**RE: Pizza Hut – Coors Blvd & Avalon Rd
Grading and Drainage Plan
Engineer's Stamp Date: 06/12/18
Hydrology File: K10D020D**

**RE: PIZZA HUT – COORS BLVD & AVALON RD
GRADING AND DRAINAGE PLAN RESPONSE TO COMMENTS
ENGINEER'S STAMP DATE 4/14/18 (K10-D020D)**

DRAINAGE REPORT

Pizza Hut Coors Blvd & Avalon Rd

Exhibit C – FIRM Map

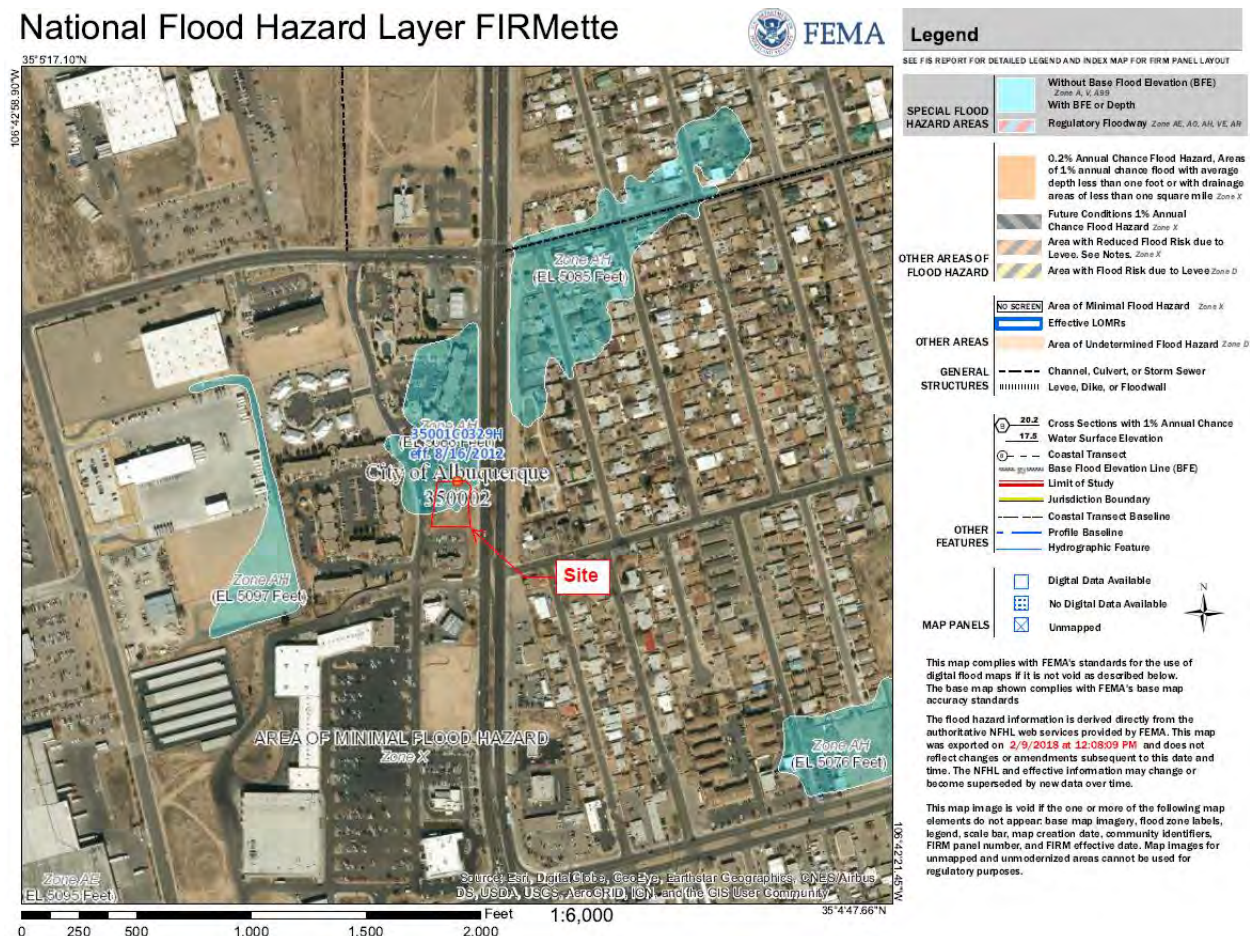
1. According to the latest Firm Map as you have indicated, this site is partially in Flood Zone AH. Please provide a written approval from FEMA prior to Hydrology approval.

Response: In a meeting with yourself and Doug Hughes on April 24, 2018 we discussed the routing of the surrounding drainage for the Bluewater Village Apartments, it was determined that a FEMA approval was not necessary since the existing drainage infrastructure was already handling the drainage that created the flood plain. An email from Doug Hughes discussing this can be found in Appendix D.

PIZZA HUT HUBBEL PLAZA	DRAWN BY DY
	GRADING/DRAINAGE PLAN FOR BUILDING PERMIT	DATE 6/8/2018
	TIERRA WEST, LLC 5571 MIDWAY PARK PLACE NE ALBUQUERQUE, NM 87109 (505) 858-3100 www.tierrawestllc.com	2017015-GRE
		SHEET # C2
RONALD R. BOHANNAN P.E. #7868		JOB # 2017015

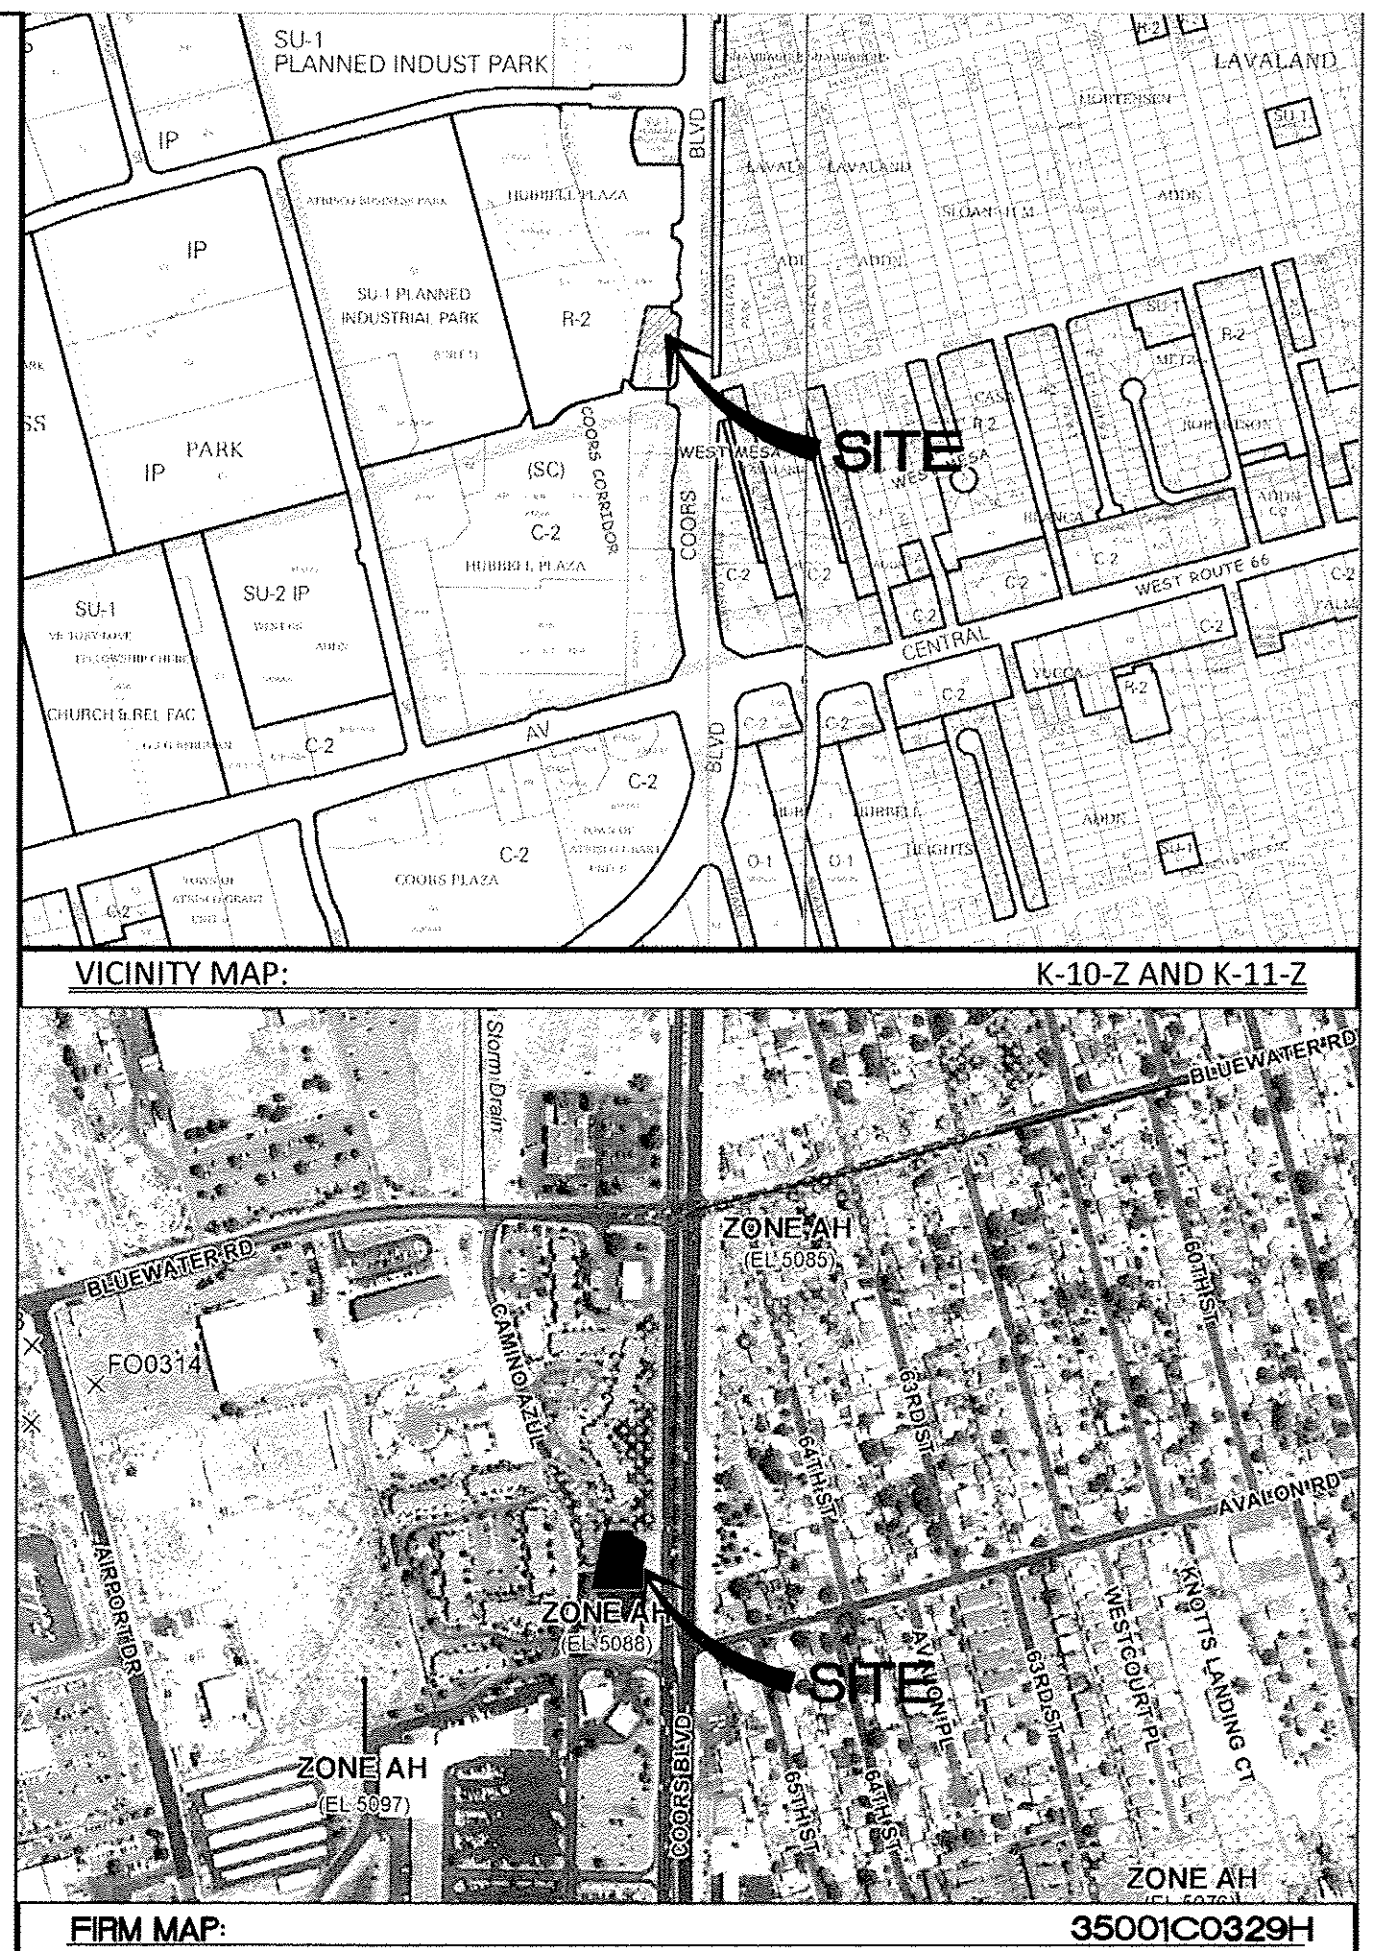
4. Please show the two existing trees and place a note that they will have to be removed.
Response: The two existing trees are now shown on the plan near the driveway at the SE corner of the property. One tree falls within the proposed driveway that will need to be removed and the other falls behind the proposed curb return of the driveway that can remain (NW of the proposed dumpster pad).

5. Please provide as-built spot elevations (top of wall and existing ground on either side of the wall) of the existing retaining wall.
Response: As-built spot elevations are now shown for both the lower east side of the wall across the entire existing span of the wall.

6. Please add the provided volume in the first flush pond.
Response: The provided volume of 963.7 CF is now currently shown on the grading plan.

SECTION A-A
NOT TO SCALE

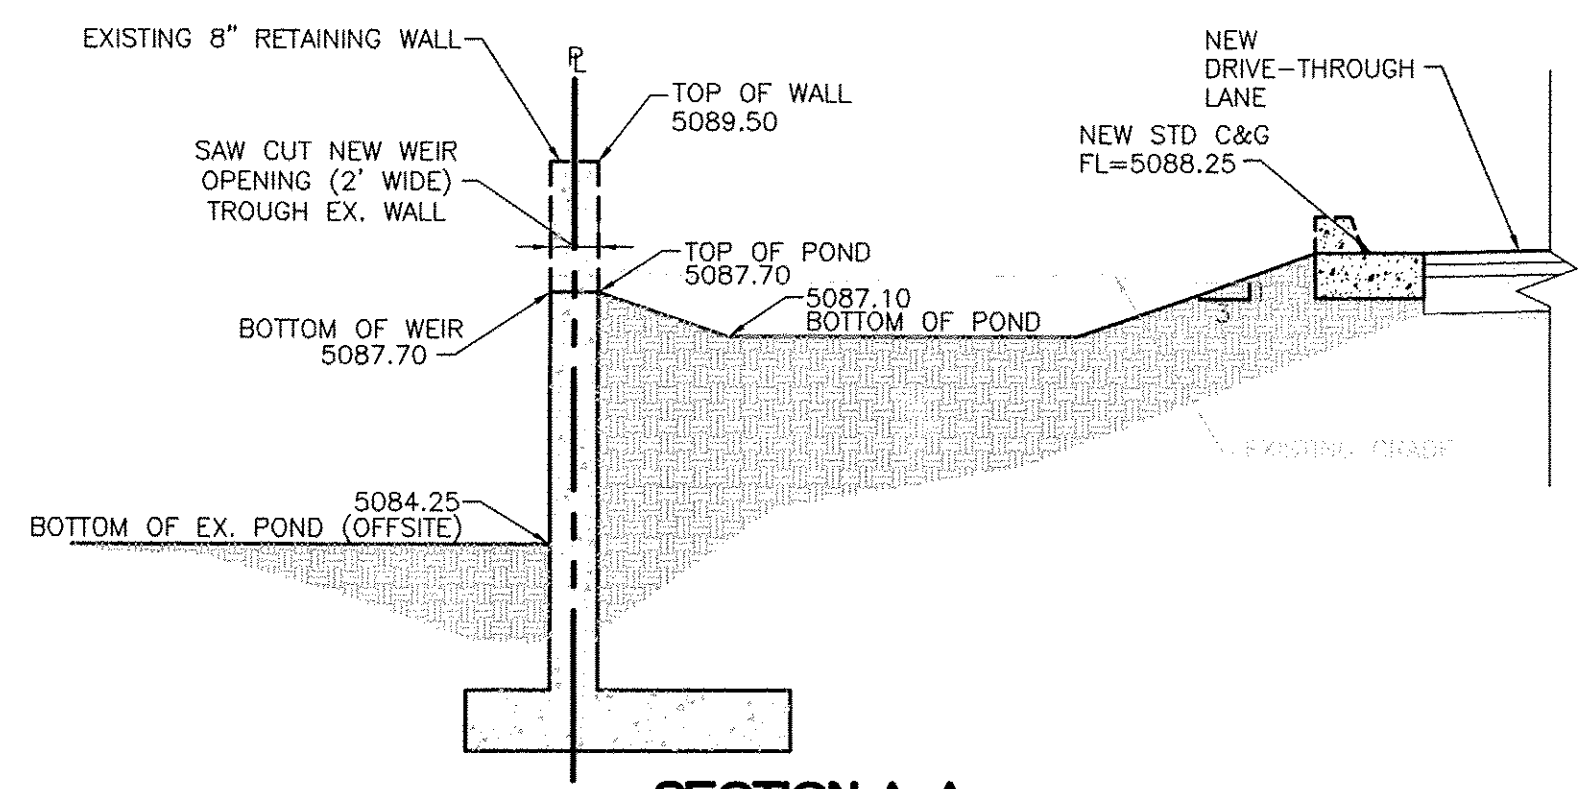
7. For Section A-A, please make these changes:

a. Please add the property line.

b. Please add the existing wall footer.

c. Please provide the width of the existing retaining wall.

d. It appears that the top of the existing pond next to retaining wall is 5085.70 and not 5087.70. This could be cleared up with the as-built topo shots in comment #5.

e. Is the existing wall footer conflicting with the proposed pond? If so, then the pond will need to be adjusted.

f. Is the wall stable after the existing earthwork excavation for the proposed pond? If not, then either provide for a new wall adjacent with the existing wall or shift the pond so it does not interfere with the existing wall.

Response: The property line was added to the cross section.

Response: The existing wall footer is now shown with the correct scaling of the wall height and existing/proposed ponds.

Response: The existing width of the retaining wall is 8" and is now shown on the cross section.

Response: The wall and pond heights were updated for clarification of the cross section. The low side of the wall where the existing wall is located is at an elevation of 5084.25 and the high side of the wall with the proposed first flush pond is at an elevation of 5087.70. The top of wall is at an elevation of 5089.50. All these elevations are shown on the cross sections along with the existing grade.

Response: The existing footer lies approximately 2' below the bottom of the existing pond at an elevation of 5082.25. This would put the footer at approximately 5.45 feet below the proposed pond and will not conflict with the finished grade.

Response: The wall was constructed to have a finished grade on the high side to be approximately 5089.50, the finished grade of the proposed pond that abuts this wall will be no higher than 5087.70 so will put less of a burden on the loading of the wall.
